**MERCURY RENEWABLES
(CARROWLEAGH) LIMITED**

**FIRLOUGH WIND FARM, CO. MAYO
AND
HYDROGEN PLANT, CO. SLIGO**

**RESPONSE TO THIRD PARTY SUBMISSIONS AND
OBSERVATIONS
PLANNING APPLICATION REFERENCE ABP-317560-23**

November 2023

Figure 3.1: Consultation Distance and Inner Risk Zones

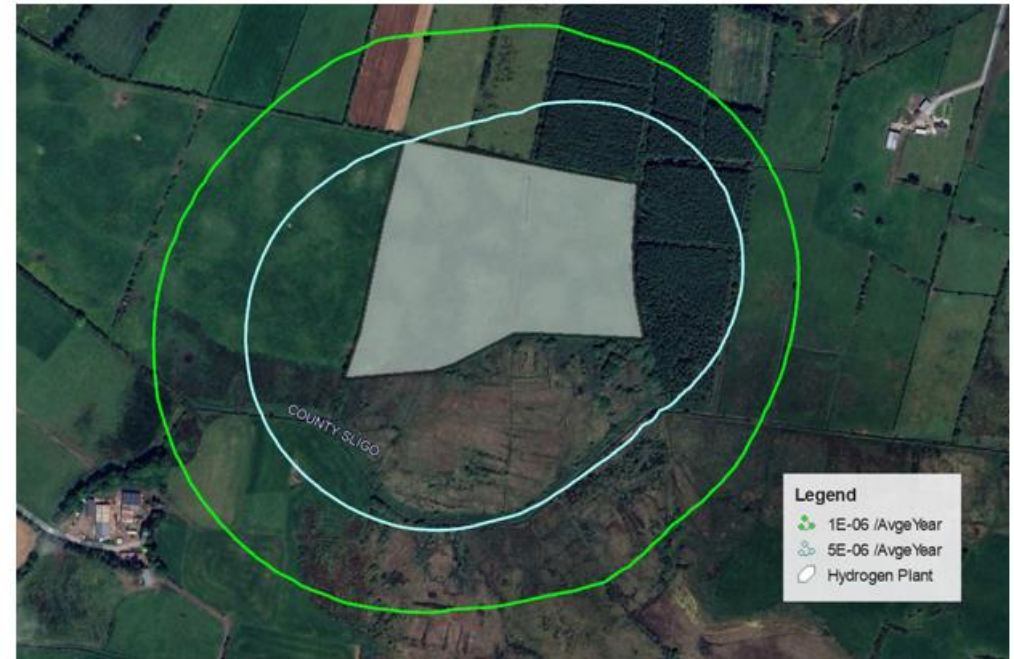
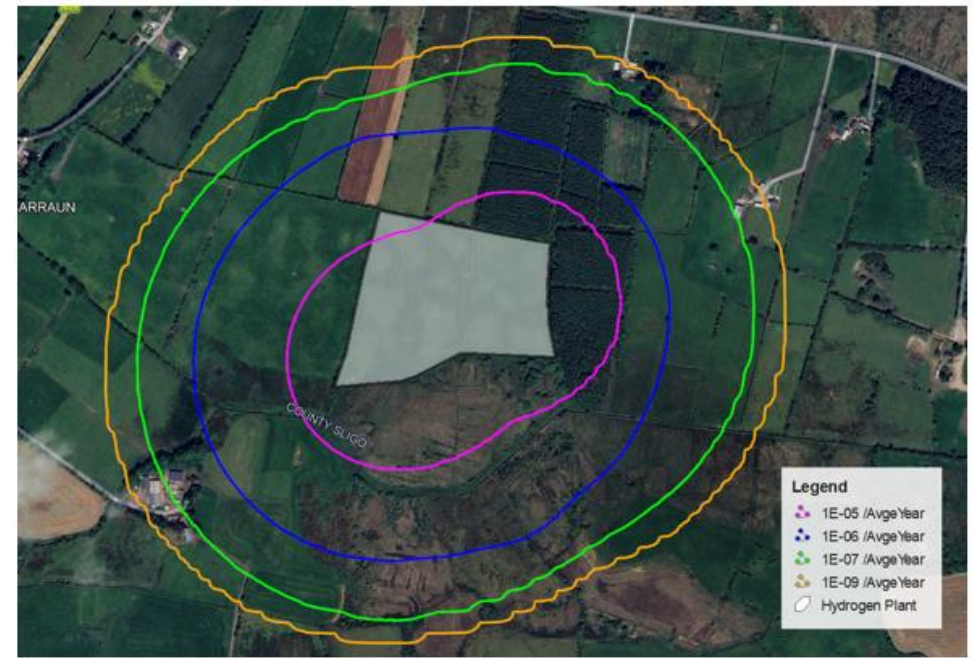
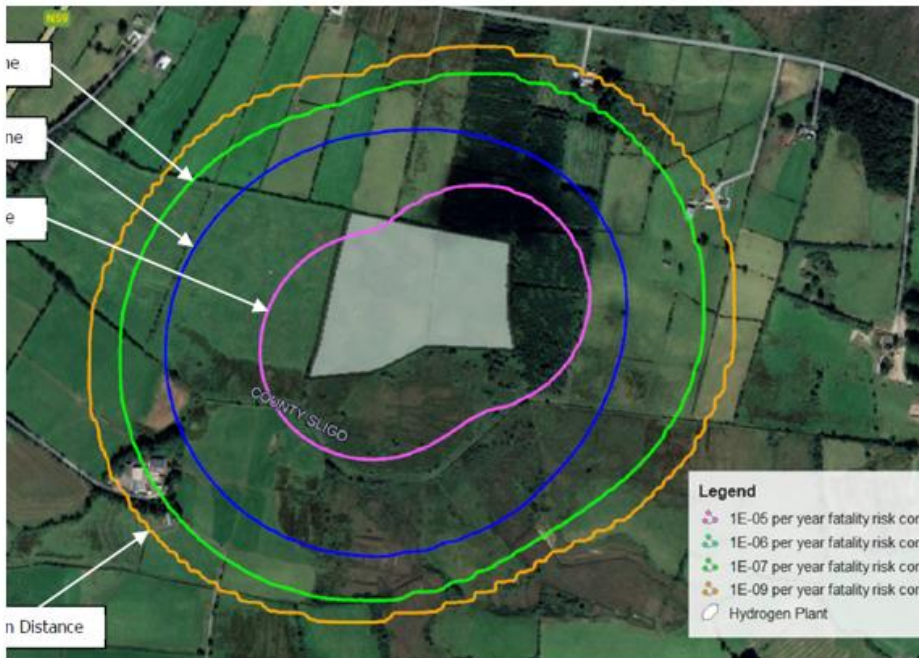
“7. Appendix D: The overpressure values presented are not consistent with those set out in section 2.4 of the TLUP, review and amend or provide justification for differing over pressure values.”

The overpressure values in Appendix D of the QRA have been updated to those values provided in the TLUP guidance document. This does not change the overall conclusions of the QRA. The updates have an insignificant impact on contours, **see Figures 3.1 and 3.2** above.

Figure 4.1: Zone of Contribution for the Hydrogen Plant.

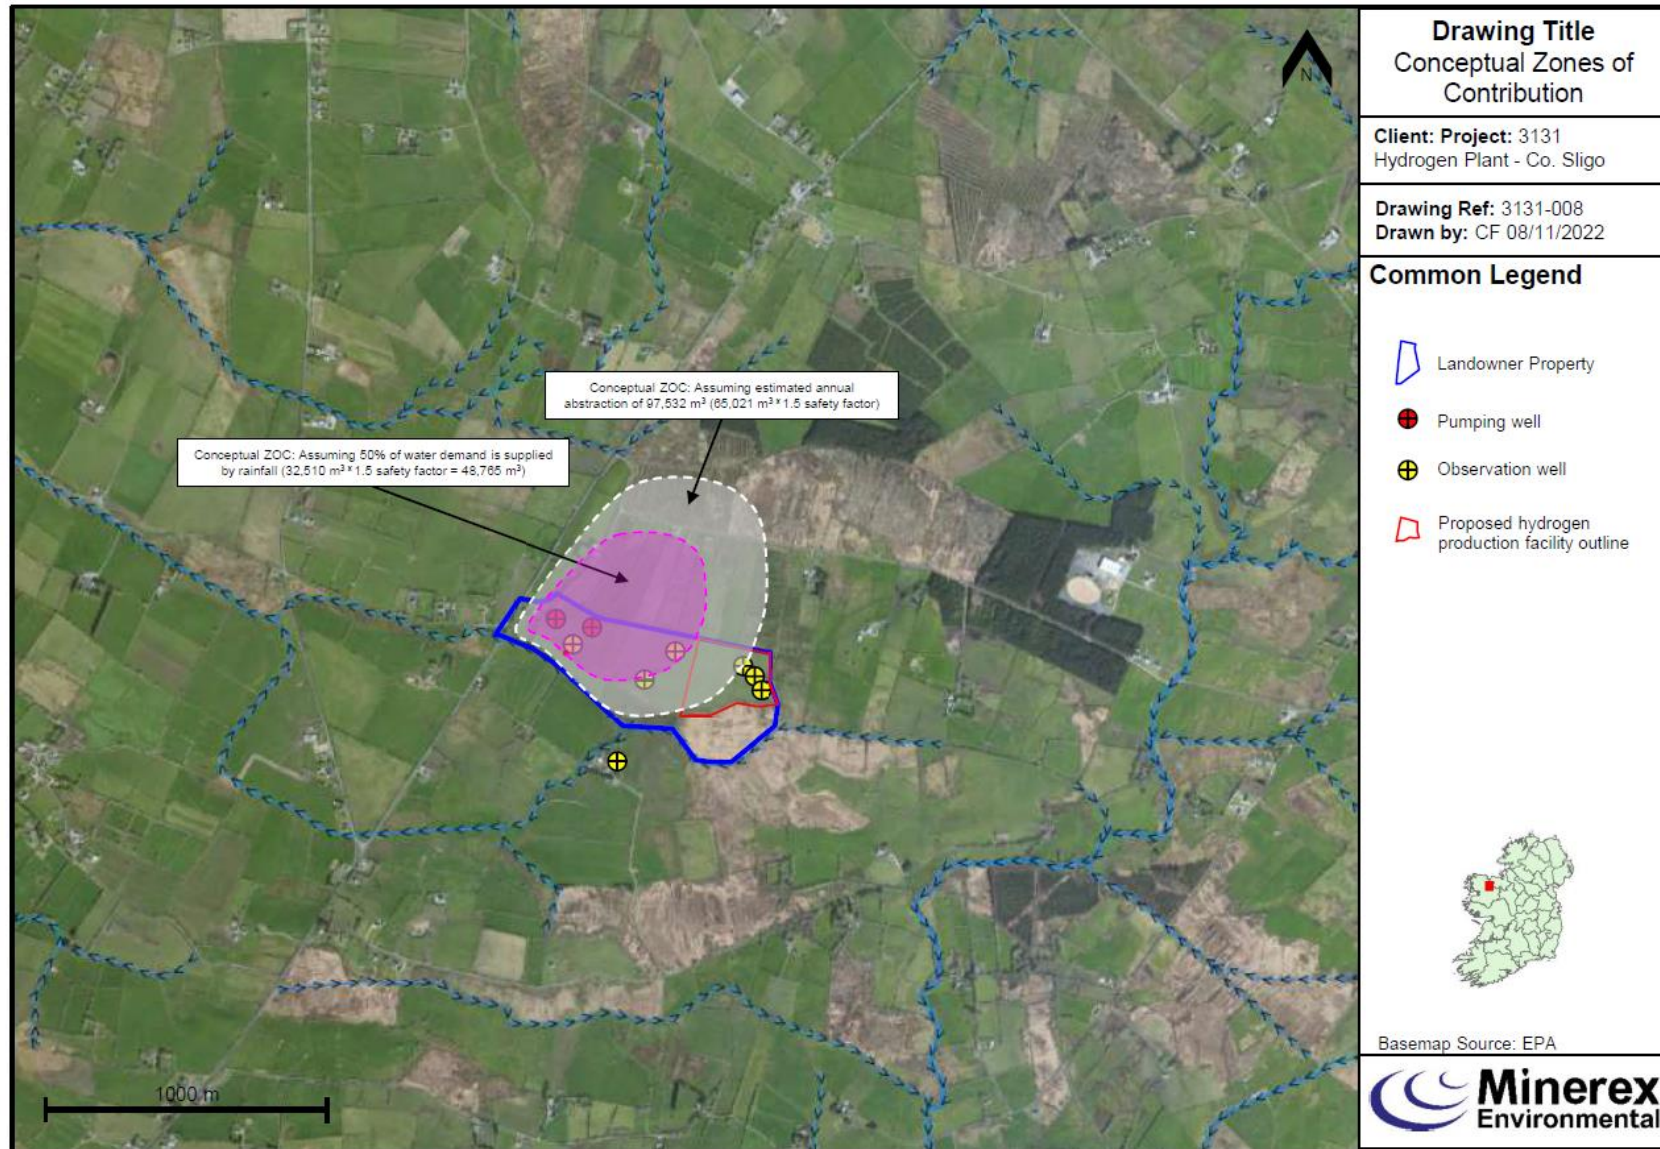
"The Wastewater Quality & Discharge Report states that the Dooyeaghny/ Newtown River may receive a relatively high volume of groundwater discharge: Mercury Renewables must demonstrate that there will be no impact on the base river flow within the Dooyeaghny/ Newtown River as a result of the proposed groundwater abstraction. A reduction in the base flow during drought conditions will exasperate the impacts of climate change on this river increasing the pressure of high water temperatures and low flow conditions on salmonids within the catchment."

The Ground Water Assessment included in Appendix 9.8 of the EIAR modelled the Zone of Contribution (ZOC) for the groundwater abstraction. This map can be seen in Figure 4.1 of

this report. The Ground Water Assessment states that; The zone of contribution is likely predominantly to the north of the site consistent with local topography. Tributaries for the Newtown River are outside the ZOC including the worst case scenario where no rainwater harvesting is used. Under worst case scenarios, the Hydrogen Plant will use stored rainwater, mains water and/or cease production until conditions become favourable.
